RE: Case No. 2020-00272

Electronic Application of Flat Run Solar LLC for a Certificate of Construction for an Approximately 55 Megawatt Merchant Electric Solar Generating Facility in Taylor County, Kentucky Pursuant to KRS 278.700 and 807 KAR 5:110

Review and Evaluation of Flat Run Solar, LLC Siting Assessment Report

July 8, 2021

Figure C-1.
Preliminary Project Layout

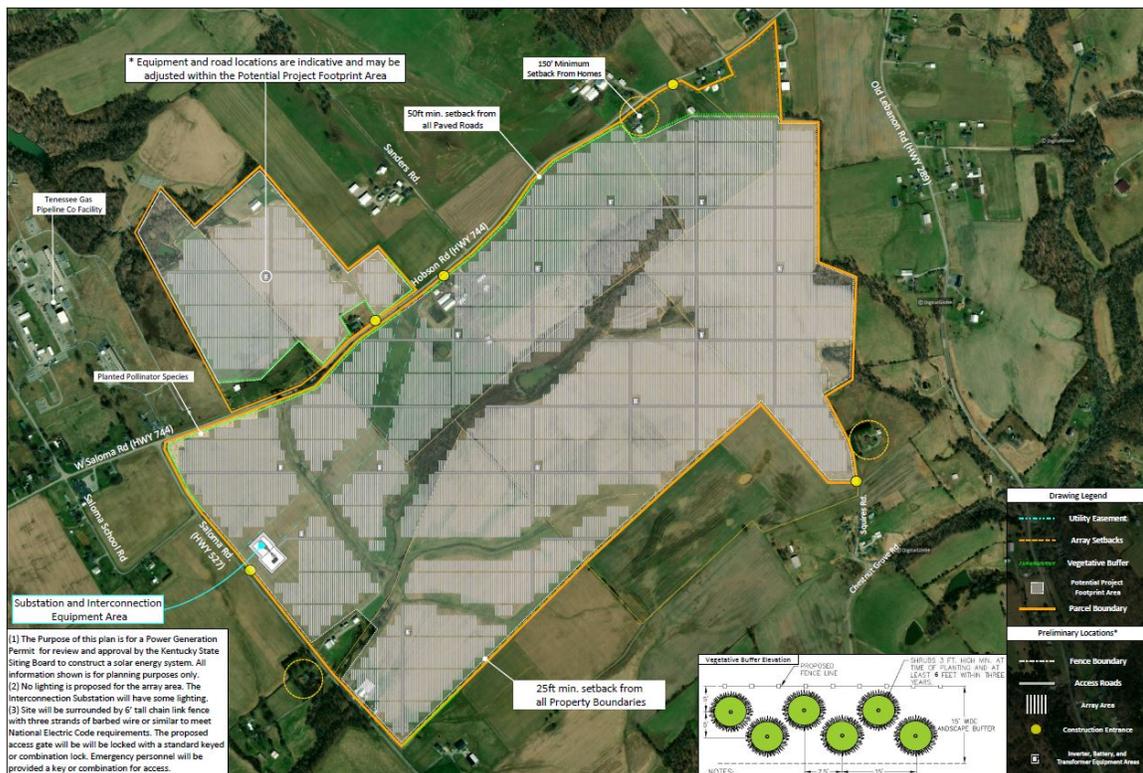
However, the legend included in Attachment A (Figure C-1 in this section) describes these as “Construction Entrances,” and it is not clear from the application or SAR if these entrances would continue to function as access points during the operational lifetime of the proposed Flat Run project. Further information regarding operational entrances is provided later, on page C-9 and C-10 in this section of BBC’s report.

- Flat Run Solar should provide a final site layout plan to the Siting Board upon completion of the final site design. Any change in project boundaries from the information reviewed during this evaluation should be submitted to the Siting Board for review.

Figure C-4.
Map of Nearest Neighbors

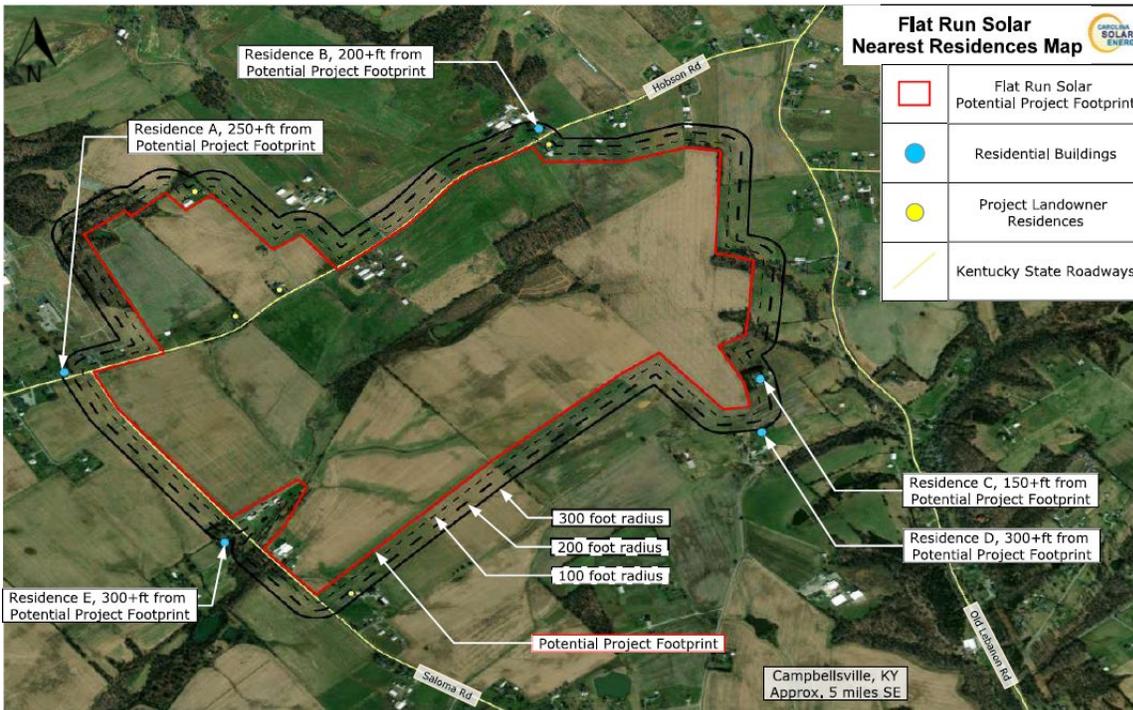
Compliance with applicable setback requirements. As noted earlier, there are a number of residences (including residents participating in the project by leasing portions of their property to Flat Run Solar and residents who are not participating) that would be within 1,000 feet of Flat Run Solar's proposed solar arrays. The *Flat Run Solar Nearest Residences Map* (provided as part of Flat Run Solar's Response to the Siting Board's Second Request for Information) further indicates there are five non-participating residences located between about 150 feet and 325 feet of the potential project footprint (as well as five participating residences labelled as "project landowner residences" that are either within the project footprint or within 300 feet of the footprint.) There are also three residential neighborhoods within 2,000 feet of the potential project footprint. Consequently, Flat Run Solar has indicated they will request a deviation from the statutory setback requirements in favor of their proposed alternative setback requirements cited previously on pages C-8 and C-9.

BBC requested clarification on the difference between participating homes (i.e., homes belonging to landowners leasing land to the project) and non-participating homes with respect to the applicant's proposed 150-foot setback from any solar equipment (SAR, page 11). The applicant responded that the 150-foot proposed setback would only apply to non-participating homes. In their response, the applicant noted:

- If the Siting Board chooses to grant Flat Run Solar’s request for a deviation from the statutory setback requirements, Flat Run Solar should be required to provide at least a 150-foot minimum setback from the project footprint to the nearest non-participating residences (as the applicant has proposed). Flat Run Solar should also be required to provide at least a 450-foot setback between central inverters and energy storage systems and the nearest non-participating residence. Although that setback is larger than the 300-foot setback proposed by the applicant, the 450-foot setback would be more consistent with previous Siting Board orders, and would provide more protection to nearby landowners from potential operating noise. The larger setback does not appear to be overly burdensome given the figure the applicant provided in their response to the Second Request for Information showing representative locations for
